STAFF REPORT

19-049-PC

Study Session/HuHanTwo, LLC/201 El Camino Real

SHEET NUMBER
A-1.7

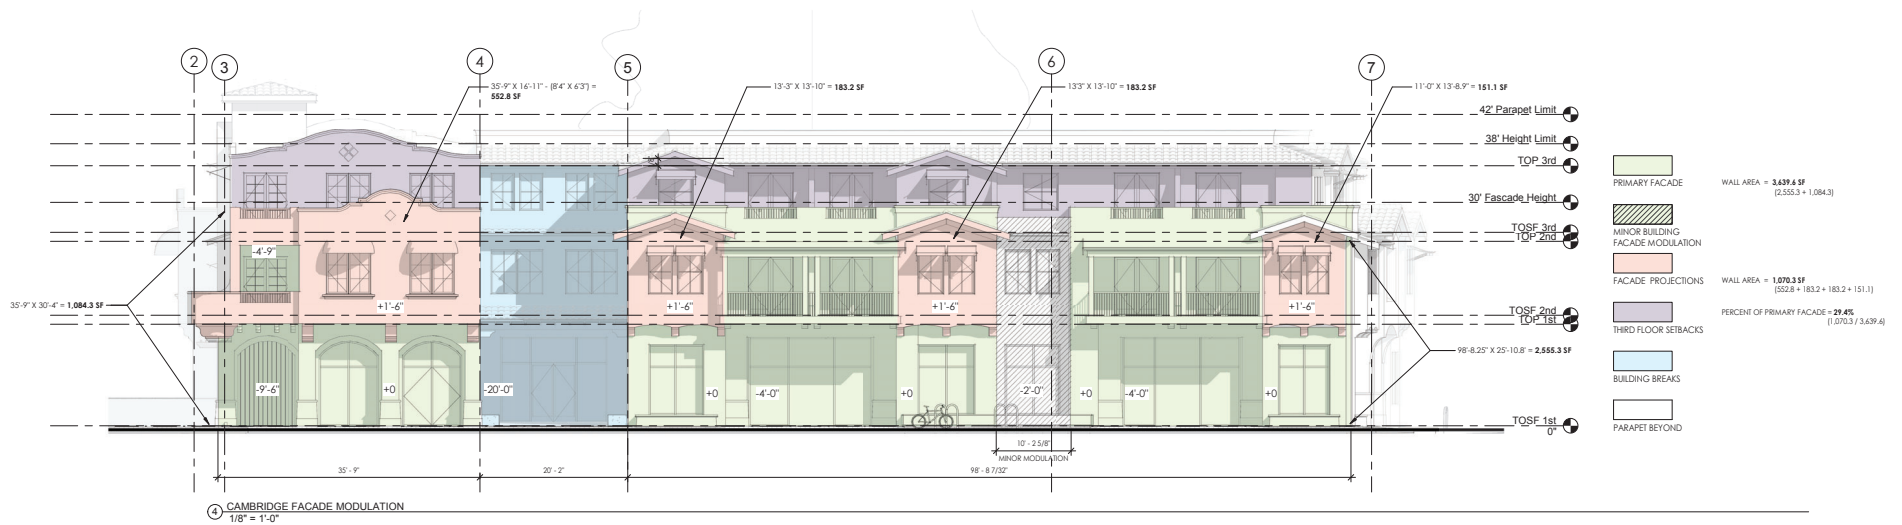
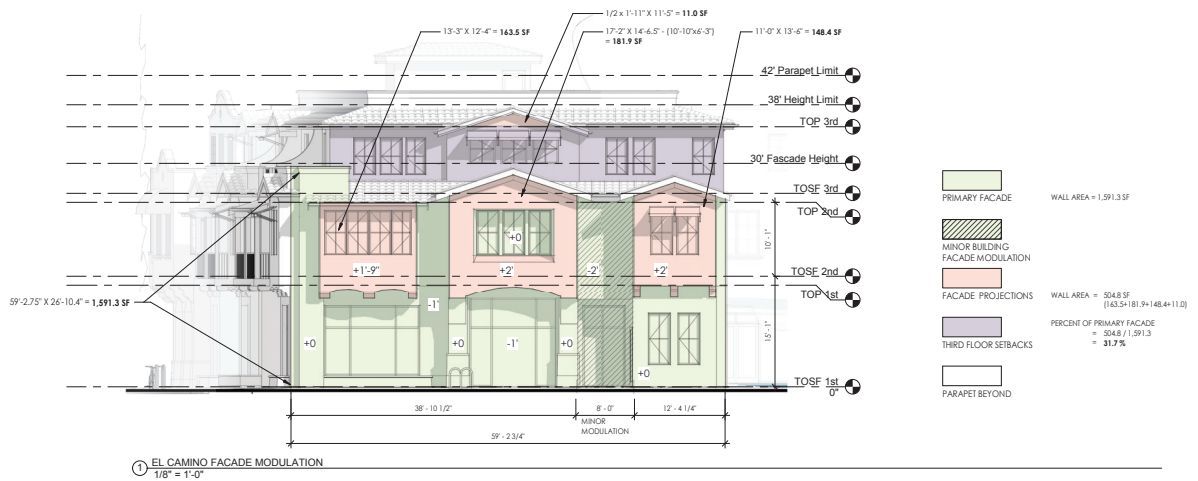
- The building projections value needs to be recalculated along Cambridge Avenue to include all second-story balconies as a façade projection, including the minor modulation in the primary façade. With these revisions, the total area of all building projections appear to still not exceed 35% of the primary building façade area, which will need to be further revised.
- The project plans have not yet demonstrated transparency diagrams or calculations at this time. Staff would review and confirm compliance as the plans get further refined.

SHEET NUMBER
A-4.2

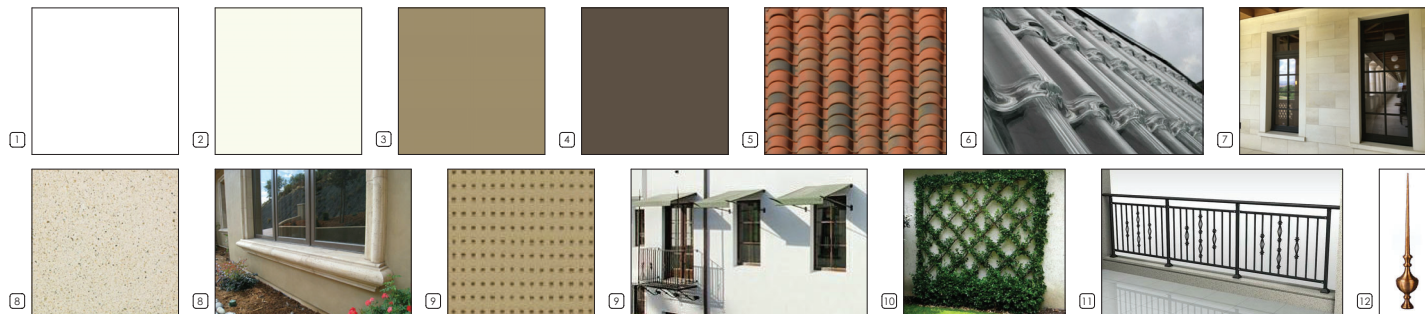
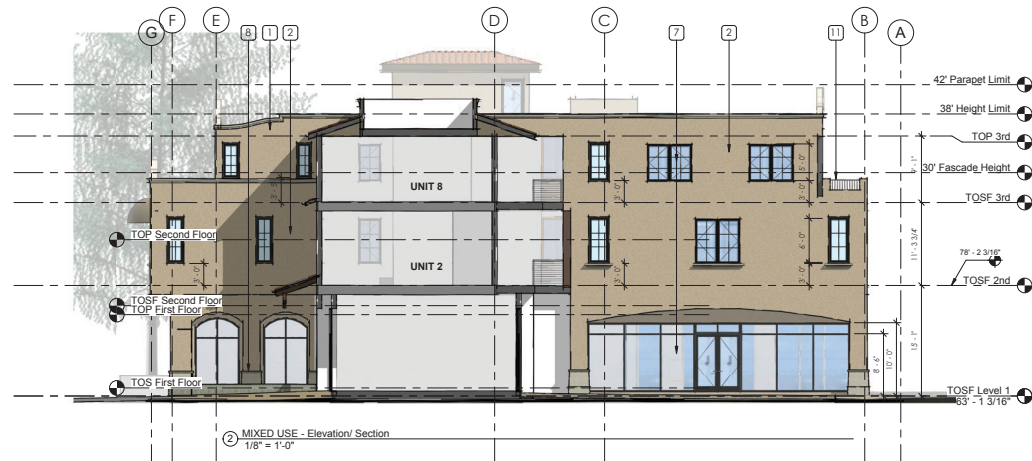
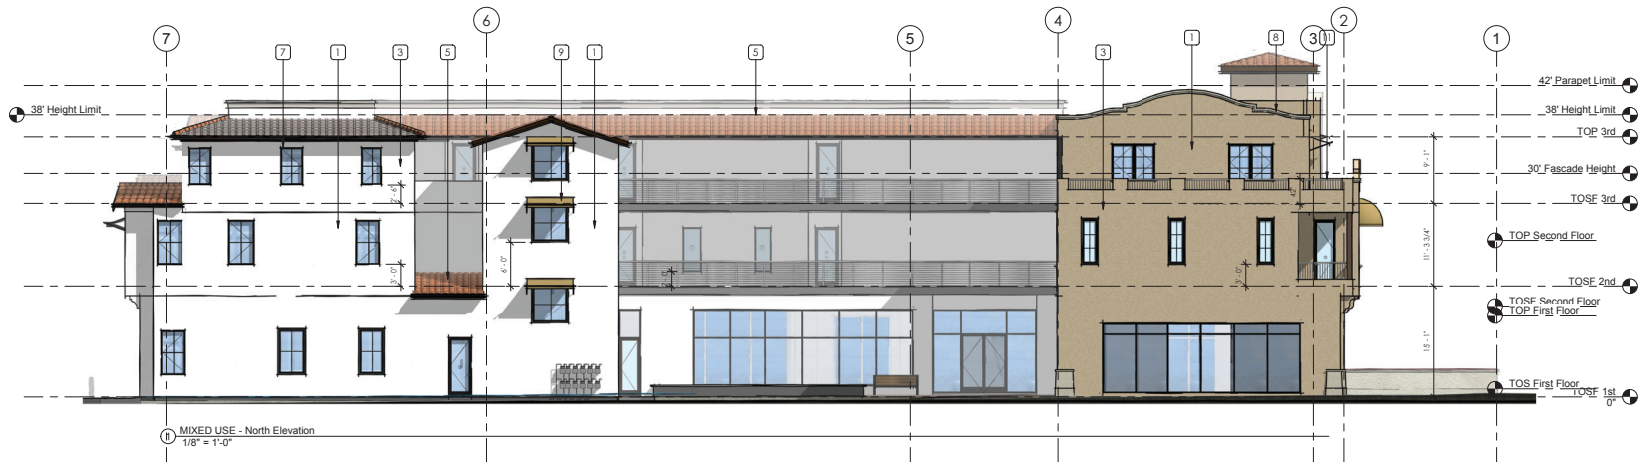
- Add tile or other accent materials to the stucco color change from white to tan at the major modulation on the Cambridge Avenue façade to enhance the visual transition between forms.
- Further emphasize the minor modulation along Cambridge Avenue, specifically at the bedroom window for Unit 5, to accentuate the modulation from other windows/wall surfaces.
- To enhance the minor modulation along El Camino Real, refine the façade elements to present more

- Planning Commission could consider whether the retail entry (facing Cambridge Avenue) should have some tile or similar accents to the façade treatment to further supplement its visual prominence.
